COLORADO DEPARTMENT OF HEALTH

Re: Annual Inspection of Wastewater Treatment Facilities for Terry Tunnel,
Mayflower Mill and American Tunnel, respectively, CPDES Permit No.
CO-0036056, CO-0000426, and CO-0027529, San Juan County

Sunnyside Gold Corporation
American Tunnel
Mine Drainage Treatment Facility
Permit No. CO-0027529
San Juan County
Figure 3

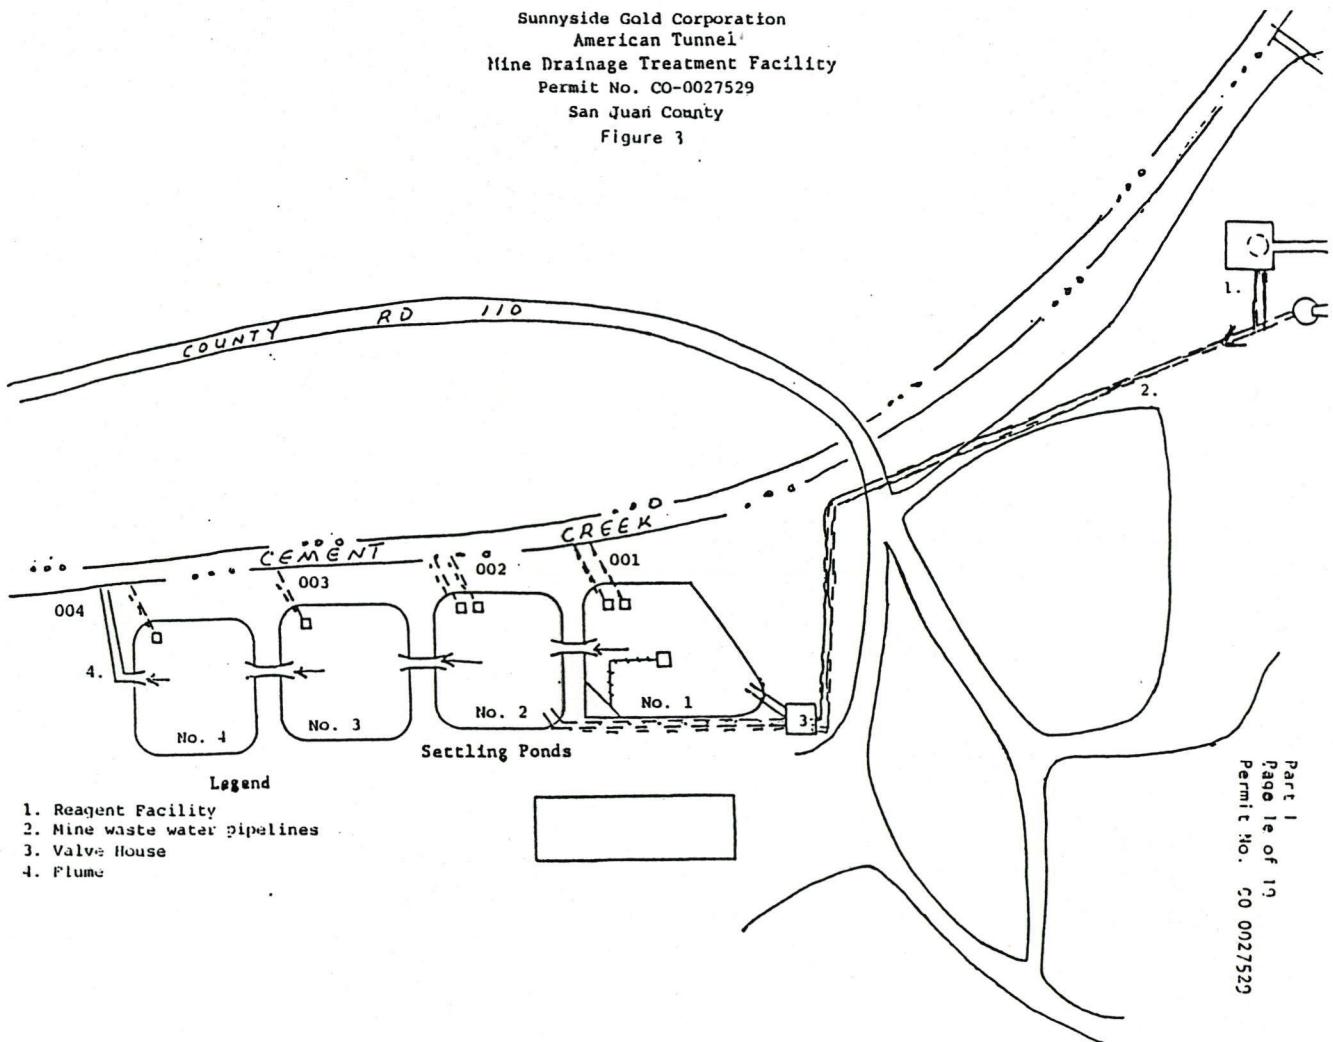
Treatment Facility Evaluation Treatment of drainage water by pH adjustment (lime), flocculation, precipitation, settling in 4 ponds in series. They are presently treating 3/4 of the water and blending with remaining 1/4. The facility has frequent power failures which upsets the treatment process. Additionally, the ponds appear to be full of sludge and are short circuiting.

Facility Evaluation vs. Permit Due to the high frequency of power failures, I recommend that they install a back-up power supply. Additionally, I think improvements should be made to the ponds to prevent short circuiting. Regarding the water used for showering, signs (NON-POTABLE WATER) should be posted at taps for the workers' safety.

Facility Deficiencies The treatment facility needs a back-up power supply, the ponds are full of sludge and are short circuiting.

Needed/Extra Permit Conditions Require a back-up power supply.

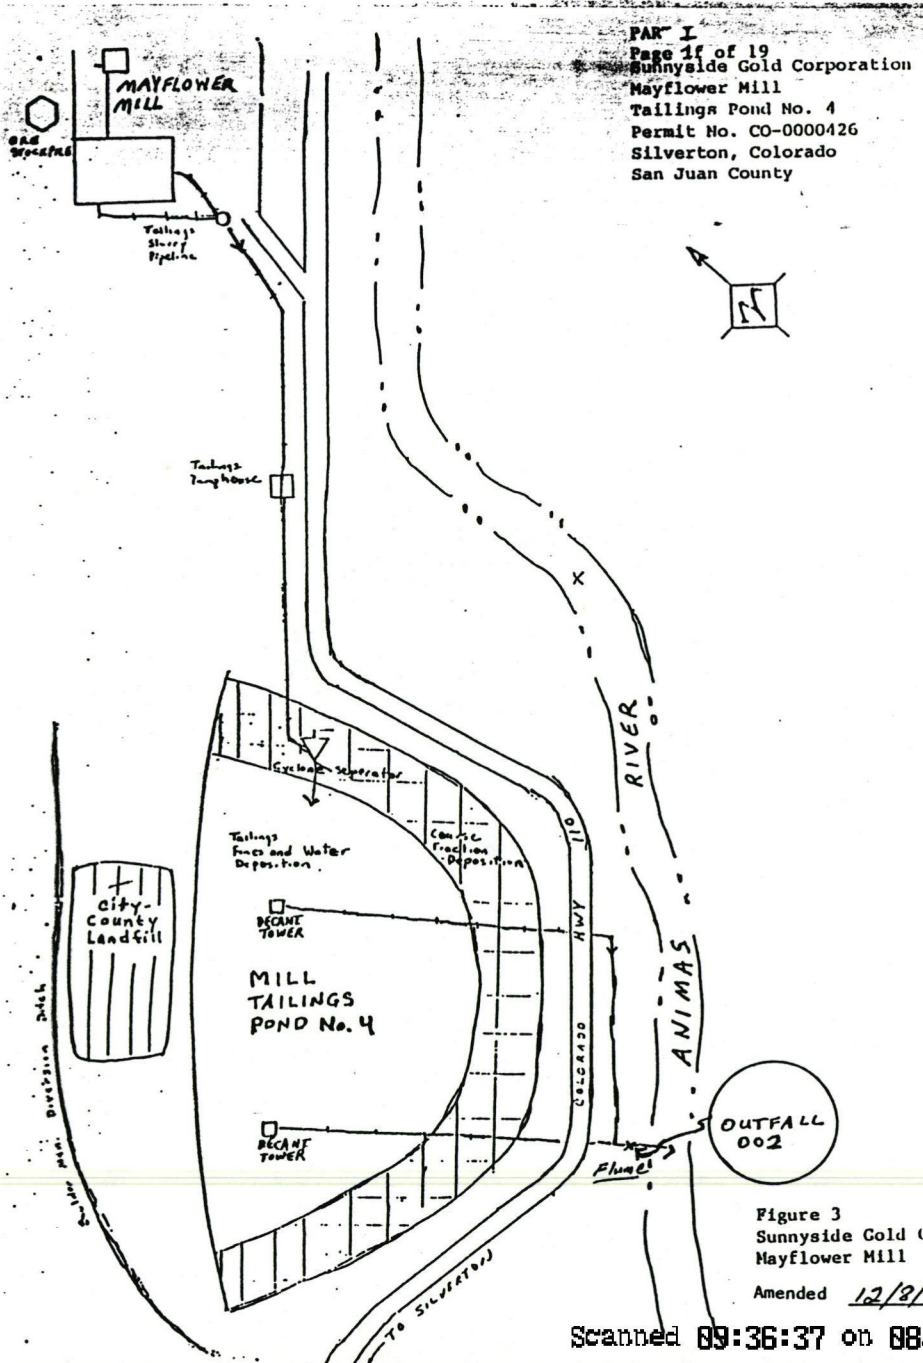
Adequacy of Materials Containment Plan (MCP) Chemicals should be stored in a better
manner. Presently they are stored on pallets outside of the mill in an area that is
susceptible to snow slides.

Facility Evaluation vs. Permit Effluent flow measuring device does not measure
to an accuracy of 10% (the trapizoidal flume leaks and does not have a staff
gage).

Facility Deficiencies Needs a more accurate flow measuring device, and improve chemical storage.

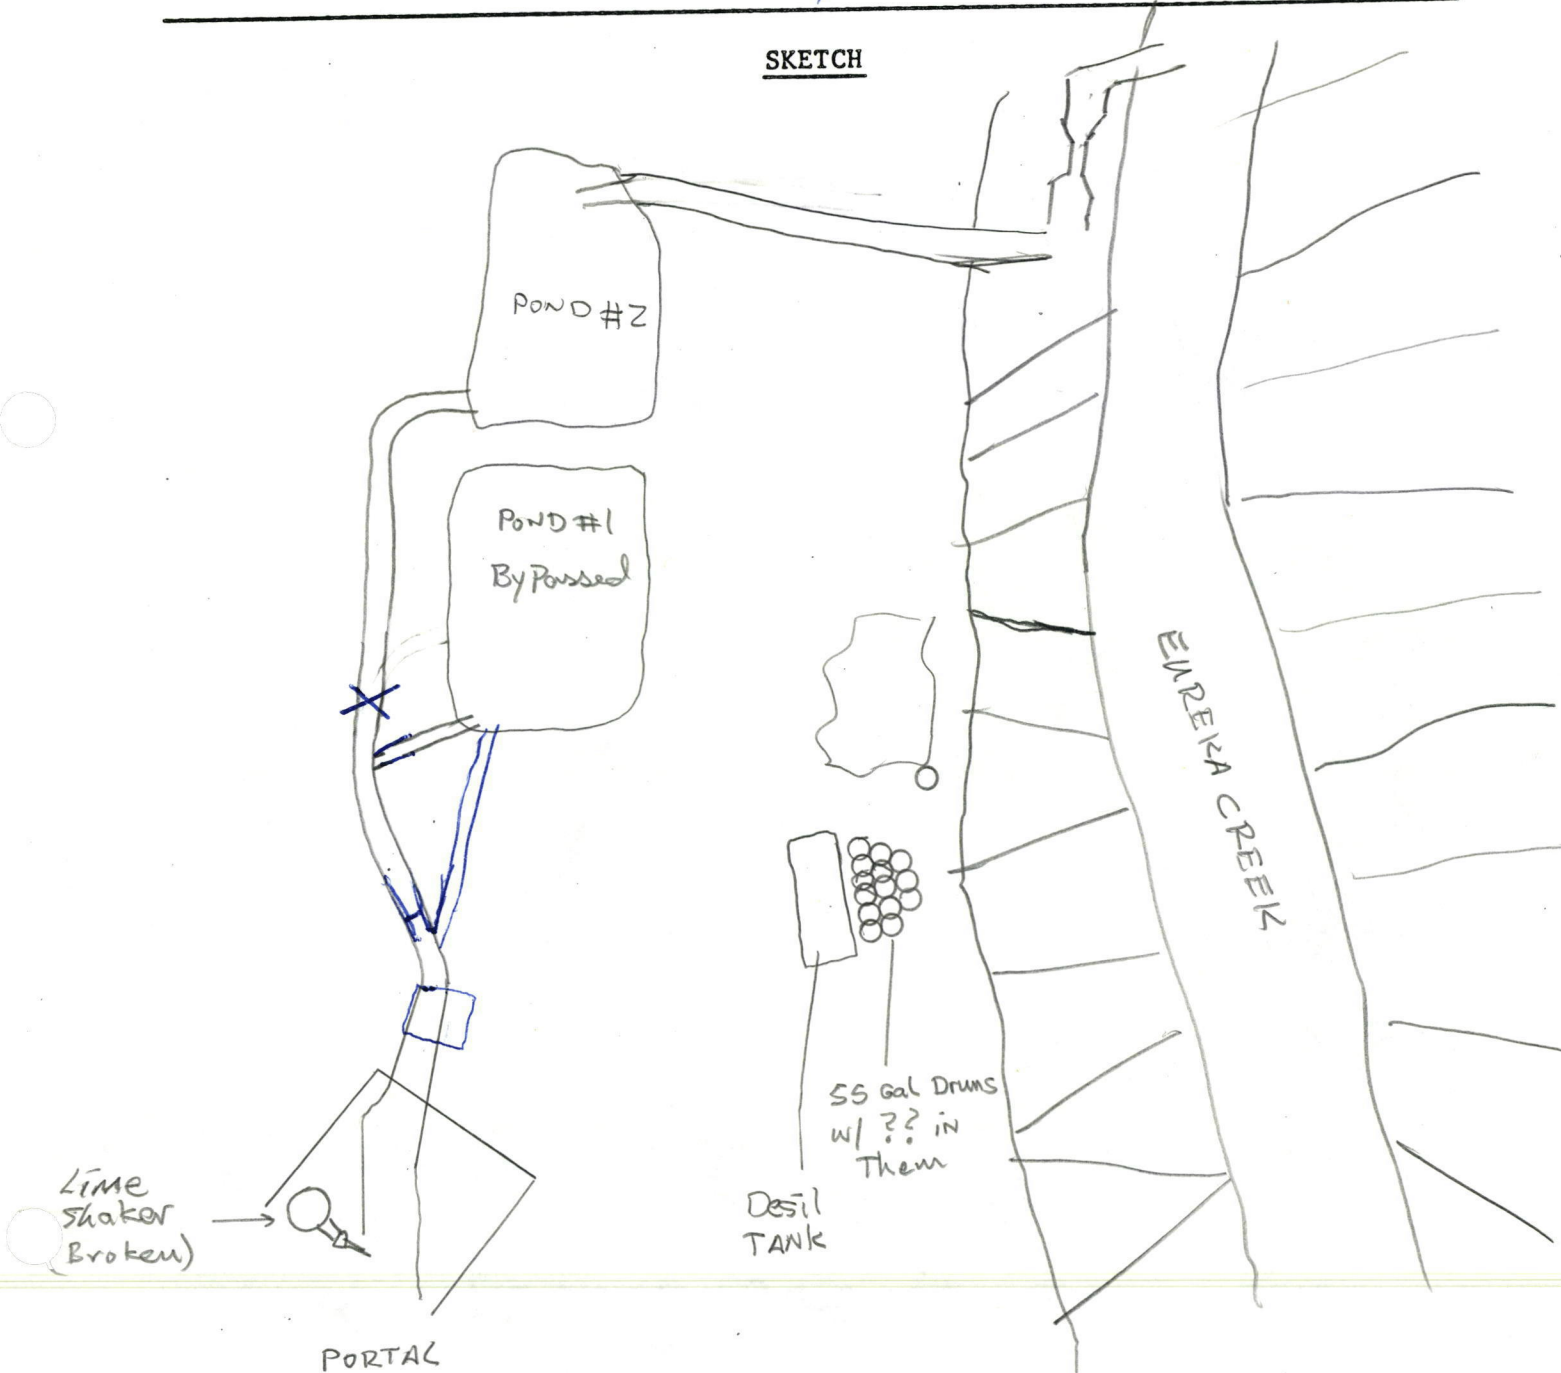
7/11/89 Hydrated lime
Adequacy of Materials Containment Plan (MCP) NOT ADEQUATE. Improper storage of fuels and other hazardous chemicals on site. 2,000 gal diesel tank w/o spill containment Misc. 55 gal drums (contents not labeled) w/o spill containment. Both near Creek.

PH Process Control new plant issue
Treatment Facility Evaluation Facility at present is not adequate. Lime feeder is broken (they are hand feeding, but very intermittently), the first settling pond is bypassed due to leakage, parshall flume has been relocated w/o a permit amendment and leaks and is not level, second pond is suspected to leak. They plan on repairing the ponds this summer, Mined land reclamation told them to move the flume, they ordere parts for the lime feeder, however their backup feeder was also broken.

→ Facility Evaluation vs. Permit ~~Need to amend your~~ permit to show relocation of parshall flume, flow measuring device not accurate to 10%, not using pond #1, not chemically treating water.

Facility Deficiencies Chemical feed system is inadequate (broken) and there is no back-up equipment. System does not operate in the winter due to access problems.
Ponds need to be lined and also cleaned, with the sludge disposed of in a proper manner.
The flow measuring device needs repair. Fuels and other chemicals (???) need to be labeled and contained in a better manner.

Needed/Extra Permit Conditions Need a more descriptive map of the facility and site in general. Presently the drawing does not function adequately to describe the treatment facility and site in enough detail.
